Meeting Notes

An electronic meeting through Zoom was held to provide a brief overview of the Traffic Calming process, to discuss the Preliminary Plan specific to Fulmer Street (Miller-Foss) as well as modifications to the Preliminary Plan. Refer to the Traffic Calming Guidebook available at a2gov.org/TrafficCalming for additional information on the Traffic Calming process. Considering the Preliminary Plan shared at Meeting #2, community feedback, street conditions, utility locations, and engineering practices, staff will develop a Final Plan for step 5: Final Polling.

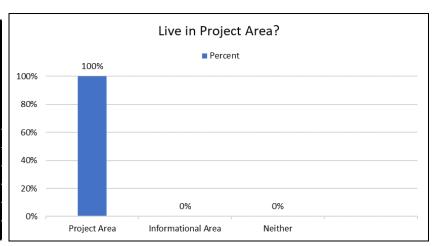
- 2. Raised Crosswalks: Will there be ramps down to the road level, then another ramp up to the crosswalk level? Or will the sidewalk essentially continue across the street with the cars raising up to the sidewalk level?

- 3. (Post-Meeting Notes) There would be ramps from the sidewalk to the crosswalk and they would be compliant with ADA requirements. There is a slight parabolic shape to the crosswalk (see the raised crosswalk at S. Forest and Woodlawn below) but for the person crossing, there shouldn't be a noticeable difference. The city's typical design is to raise the crosswalk 3 inches from the road, adding the tapers for safety to bikes and vehicles.
